NOTICE OF CHANGE

ADJUSTMENT TO CYA188 (A)(T) GLEN VALLEY, BC

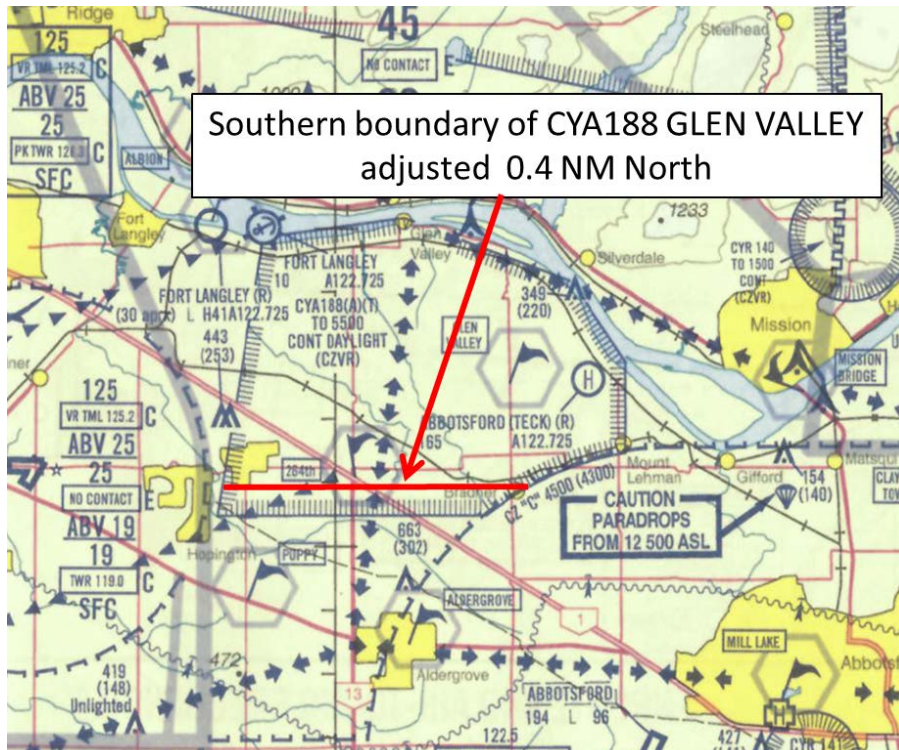
As a result of this review and the application of new IP design criteria, the southern boundary of CYA188(A)(T) GLEN VALLEY, BC must be adjusted 0.4 nautical miles (NM) north (see map sketch below). This adjustment is required for the Abbotsford airport runway 07 ILS and NDB instrument approach procedures to be compliant with the new criteria.

This change takes effect 12 October 2017 at 0901 Coordinated Universal Time (UTC). Refer to the related AIP Supplement until the amended VFR Chart **AIR 1901 - Vancouver VTA** is available in July 2018.
